**Group of Experts for the revision of the IMO/ILO/UNECE
Guidelines for Packing of Cargo Transport Units**

Proposals for amendments to the final draft of the CTU Code

**Consolidated list of proposed amendments to the draft CTU
Code (annexes)**

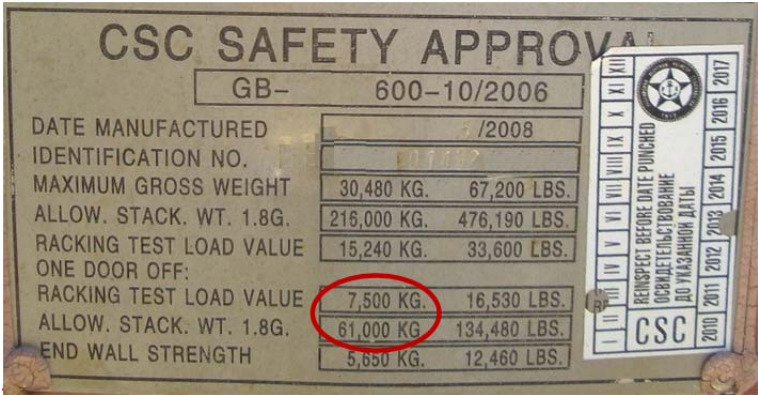
Annex	Section	Submitter(s)	Comment	Proposed text
1	5.5	USA	Amend and combine the last two sentences as follows:	<p>Row 15 and 16 show a greater risk with the load at 132% and 136% respectively even though the stack height is less. <u>When the ship rolls, any stacks in the rows where the load is greater than 100 per cent will move transversely far greater than the adjacent stacks and as a result the whole bay may fail.</u> Any of the stacks in the rows where the load is greater than 100%. When the ship rolls these stacks will move transversely far greater than the adjacent stacks and as a result the whole bay may fail.</p>
1	Figure 1.16	IMO	Replace the figure by a more illustrative one.	 <p>replaced by:</p>

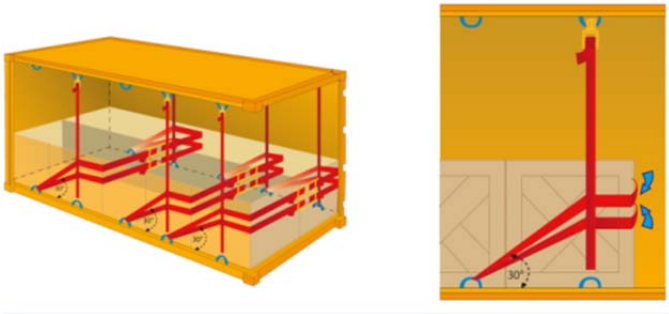
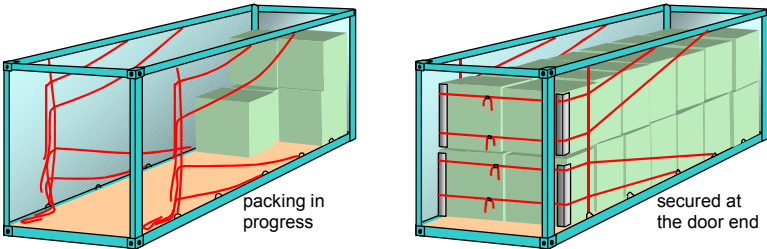
11	5	WSC / ICS	We do not agree with the inclusion of section 5 of Annex 11, which is taken from IMO's circular CSC/Circ. 138 regarding serious structural deficiencies. This circular is addressed to government inspectors. Packers are not government inspectors.	<p>5 — Containers</p> <p>5.1 — Containers, because of the handling methods employed, require additional checks to identify damage which might impede safe transport of the CTU (structural deficiencies)³.</p> <p>5.1.1 — Top rail:</p> <ul style="list-style-type: none"> • — local deformation to the rail. • — separation or cracks or tears in the rail material. <div style="display: flex; justify-content: space-around; align-items: center;"> <div style="text-align: center;">  <p>Top rail</p> </div> <div style="text-align: center;">  </div> </div> <p>5.1.2 — Bottom rail:</p> <ul style="list-style-type: none"> • — local deformation perpendicular to the rail • — separation cracks or tears in the rail's material: <ol style="list-style-type: none"> a) — of top flange or b) — of web

Annex	Section	Submitter(s)	Comment	Proposed text
				<div data-bbox="1193 212 1447 368">  <p>Bottom rail</p> </div> <div data-bbox="1480 196 1704 368">  </div> <div data-bbox="1783 196 2018 368">  </div> <p data-bbox="1167 392 1637 483"> 5.1.3 Header: • local deformation to the header • cracks or tears </p> <div data-bbox="1193 491 1447 679">  <p>Header</p> </div> <div data-bbox="1464 488 1727 683">  </div> <div data-bbox="1765 488 2047 695">  </div> <p data-bbox="1167 699 1765 790"> 5.1.4 Sill: • local and significant deformation to the sill • cracks or tears </p> <div data-bbox="1193 807 1447 963">  <p>Sill</p> </div> <div data-bbox="1487 791 1715 979">  </div> <div data-bbox="1765 791 2018 979">  </div> <p data-bbox="1167 986 1839 1077"> 5.1.5 Corner posts: • local deformation to the post in excess of 30mm • cracks or tears in any length </p> <div data-bbox="1193 1094 1447 1315">  <p>Corner posts</p> </div> <div data-bbox="1464 1078 1621 1315">  </div> <p data-bbox="1167 1361 1648 1425"> 5.1.6 Corner and intermediate fittings: • missing corner fittings </p>

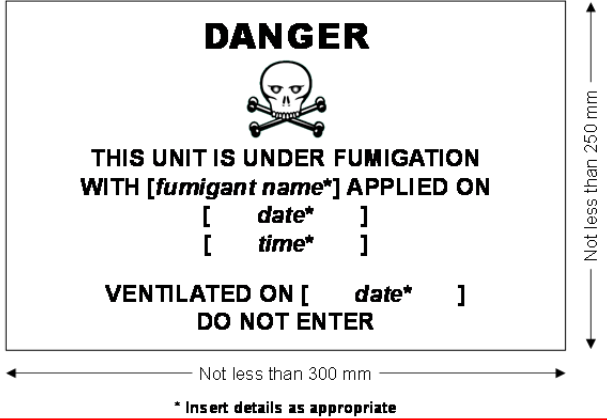
Annex	Section	Submitter(s)	Comment	Proposed text
14	Figure 14-22	IMO	Replace with following figure:	<p style="text-align: center;">Distance of cargo centre of gravity from front</p> <p style="text-align: center;">1 2 3 4 5 6 7</p>  <p>replaced by:</p> <p style="text-align: center;">Distance of cargo CoG from the front wall [m]</p> 
14	Figure 14-23	IMO	Replace with following figure:	<p style="text-align: center;">Distance of cargo centre of gravity from front</p> <p style="text-align: center;">1 2 3 4 5 6 7 8 9 10 11 12 13</p>  <p>replaced by:</p>
